51 JOYCE ROAD
EASTCHESTER, NEW YORKDWG. TITLE:
AS-BUILT FIRST FLOOR PLAN
WITH PROPOSED CHANGESDavid A. Barbuti
Architect, PC150 White Plains Road
Suite 103
Tarrytown, NY 10591
Tel : 914-909-5143
Fax : 914-909-5144

PROJECT NAME:
AS-BUILT DRAWINGS FOR:
THE STRICKER RESIDENCE
51 JOYCE ROAD
EASTCHESTER, NEW YORK

DWG. TITLE:
**AS-BUILT SECOND FLOOR AND ROOF
PLANS WITH PROPOSED CHANGES**

DWG. TITLE:
AS-BUILT ELEVATIONS
WITH PROPOSED CHANGES

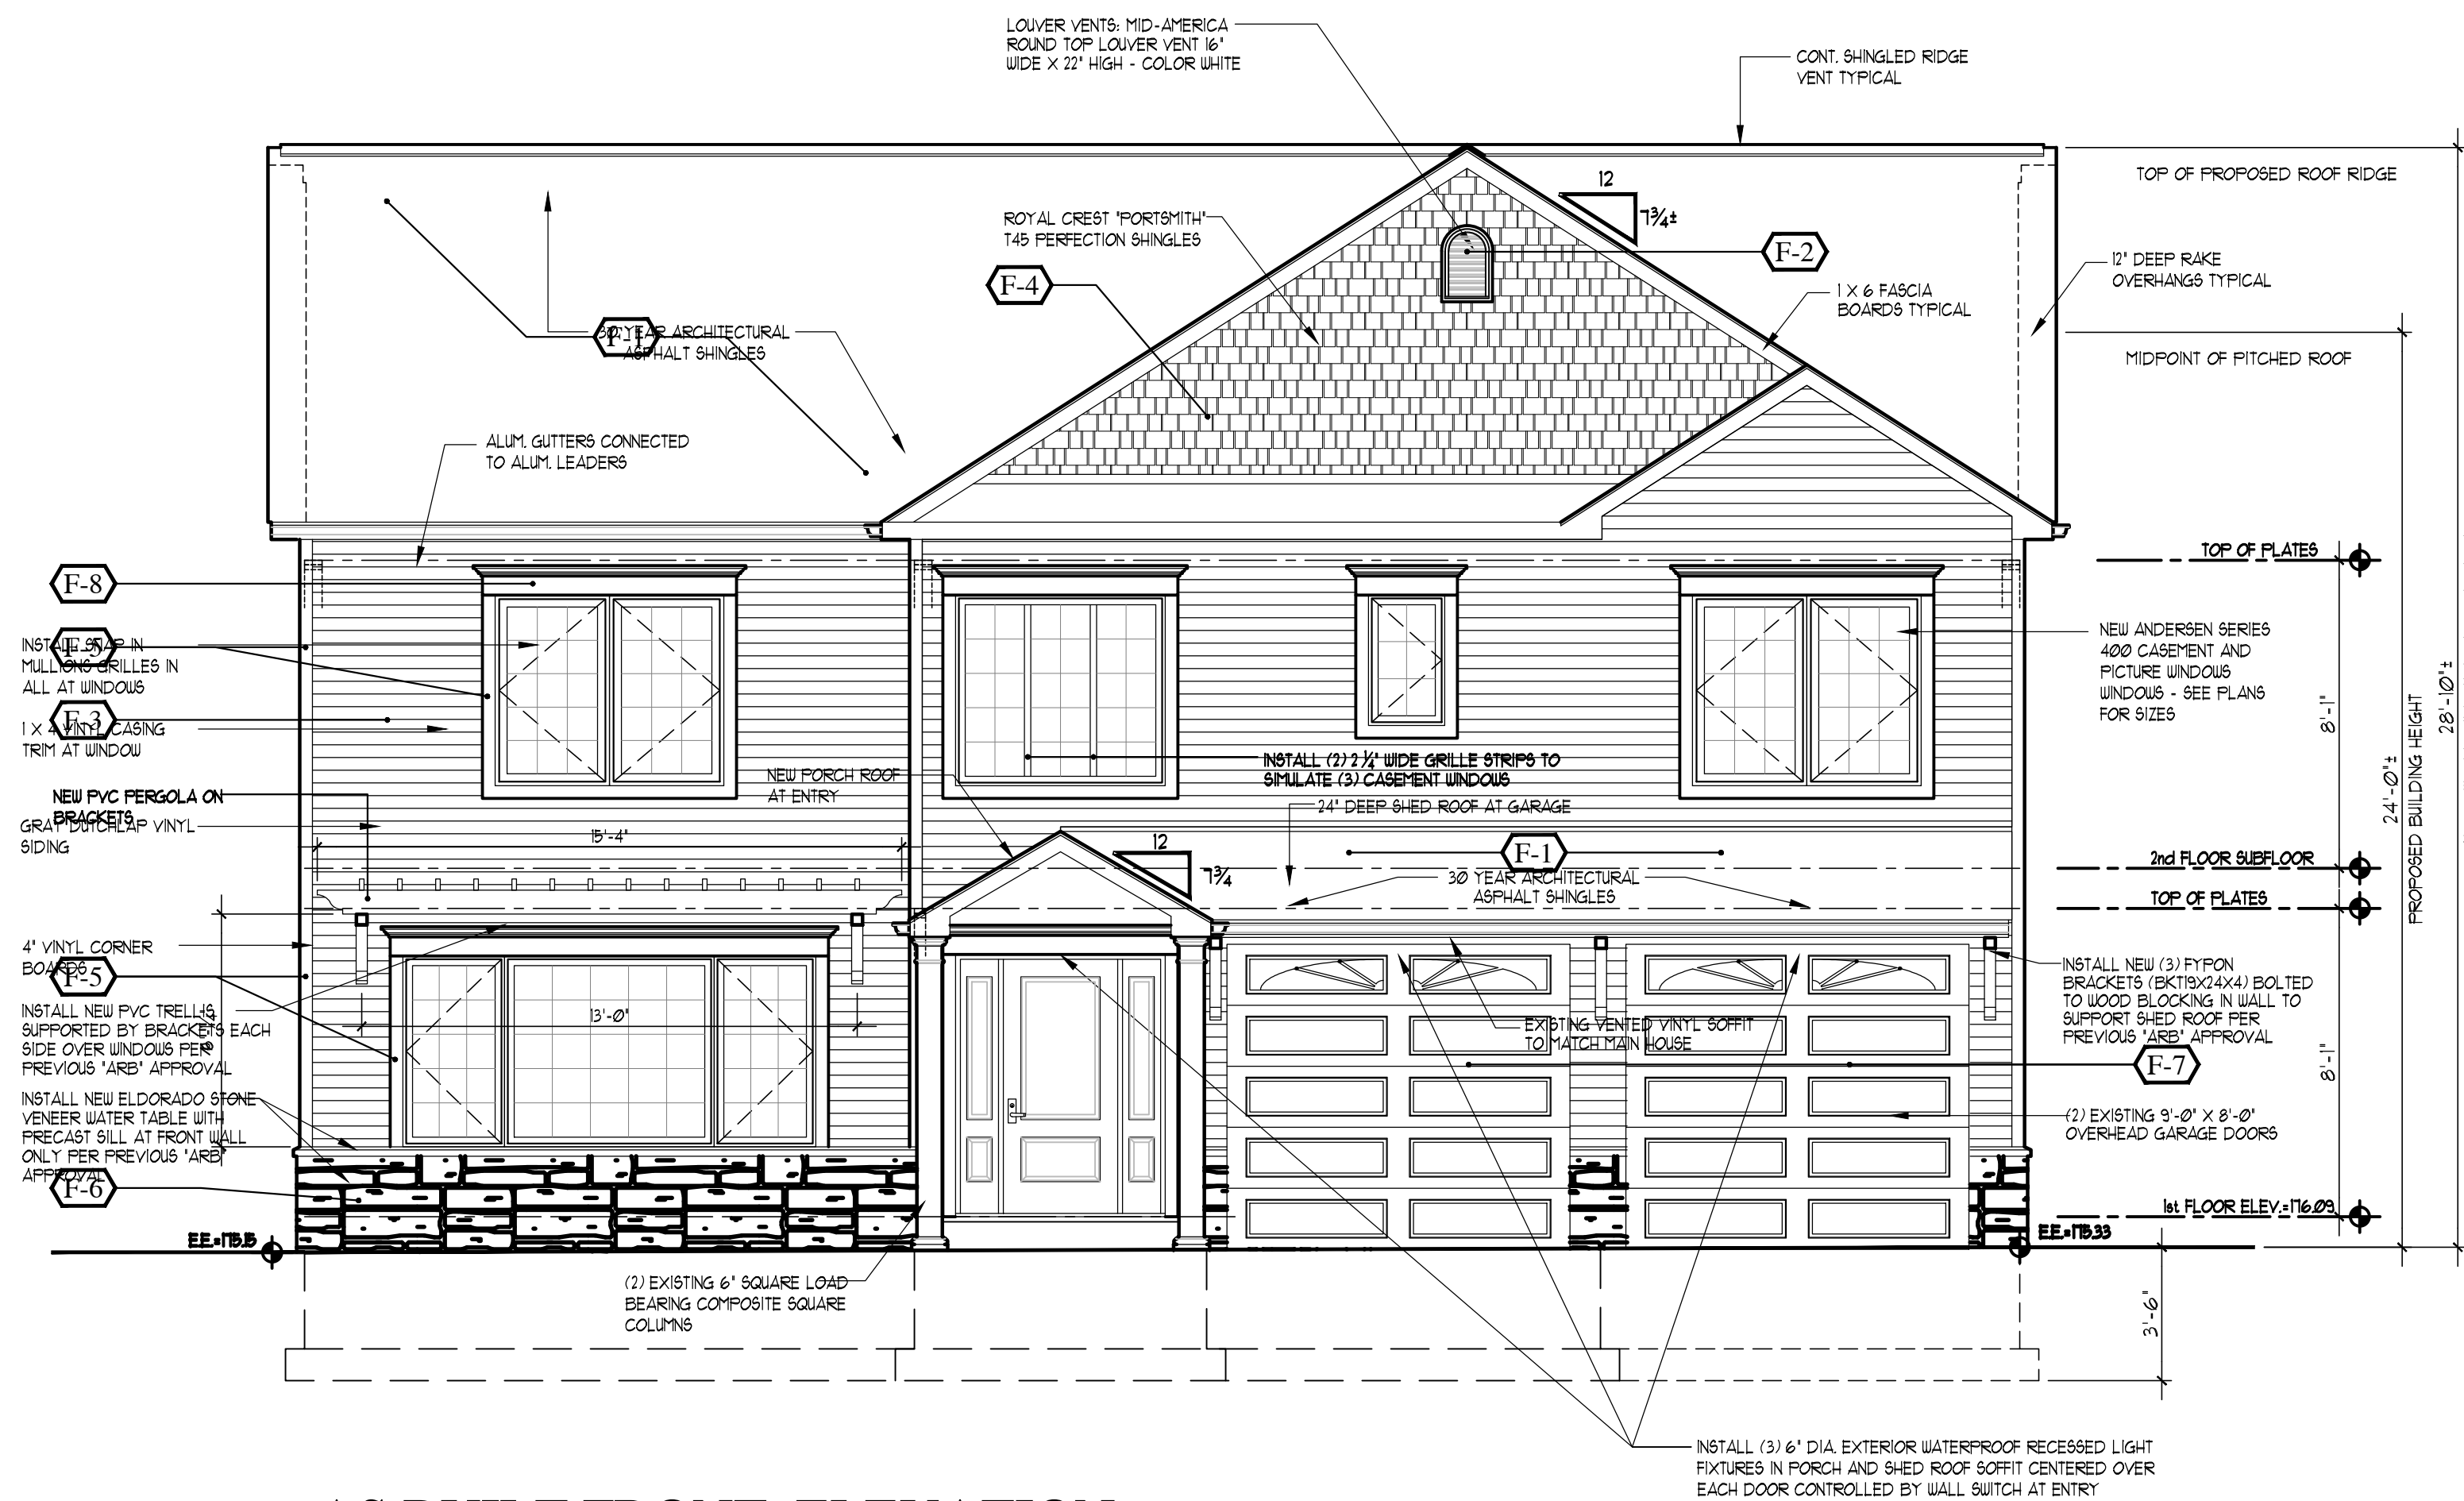
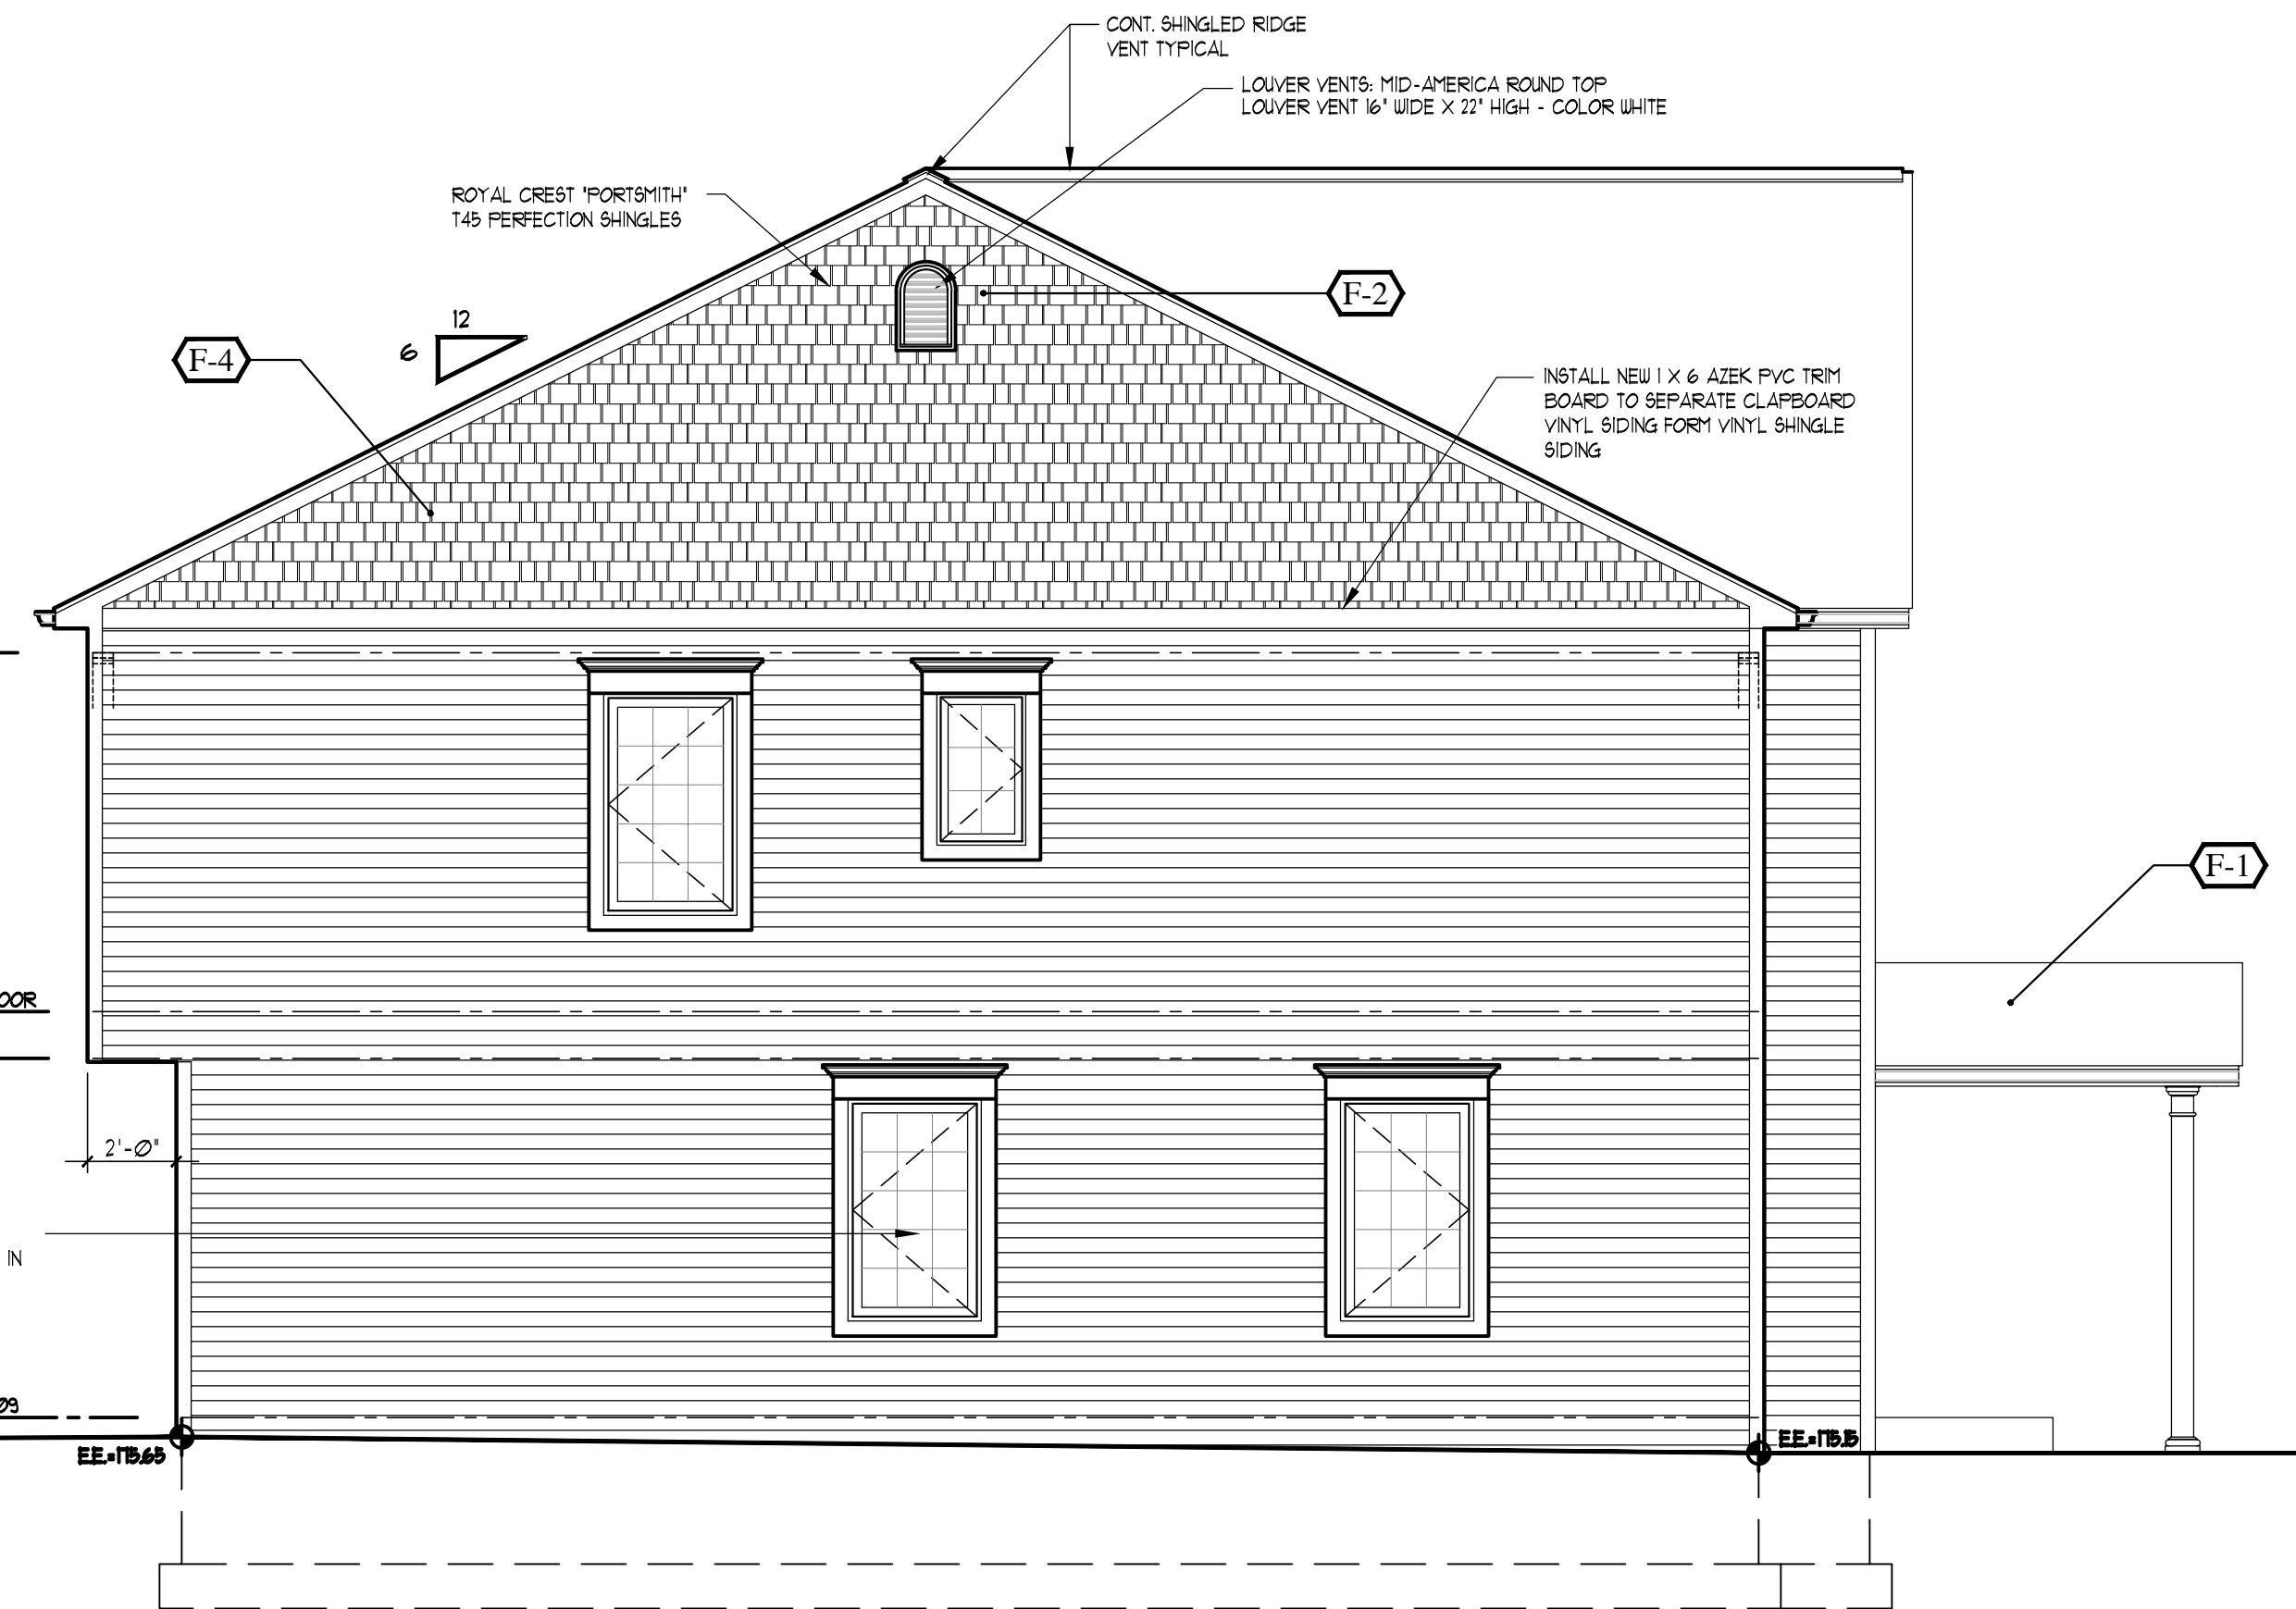
ADDED WINDOW & DOOR CASING & HEAD TRIM. REVISED LARGE PICTURE WINDOW'S GRILLE PATTERN. REVISED GARAGE DOOR STYLE TO REFLECT THE ACTUAL DOORS CHANGES REQUESTED BY ABB FOR APPROVAL.	11-27-19	C.P.	DATE	DESCRIPTION
REVISED FLOOR PLANS AND ELEVATIONS TO REVISED FLOOR PLANS AND ELEVATIONS TO SHOW AS-BUILT CONDITIONS AND PROPOSED CHANGES TO GET NEW ABB APPROVAL.	10-21-19	C.P.	DATE	DESCRIPTION
REVISED ELEVATIONS TO SHOW PROPOSED CHANGES REQUESTED BY ABB FOR APPROVAL.	11-27-19	C.P.	DATE	DESCRIPTION
REVISED FLOOR PLANS AND ELEVATIONS TO REVISED FLOOR PLANS AND ELEVATIONS TO SHOW AS-BUILT CONDITIONS AND PROPOSED CHANGES TO GET NEW ABB APPROVAL.	10-21-19	C.P.	DATE	DESCRIPTION
ADDED WINDOW & DOOR CASING & HEAD TRIM. REVISED LARGE PICTURE WINDOW'S GRILLE PATTERN. REVISED GARAGE DOOR STYLE TO REFLECT THE ACTUAL DOORS CHANGES REQUESTED BY ABB FOR APPROVAL.	11-27-19	C.P.	DATE	DESCRIPTION
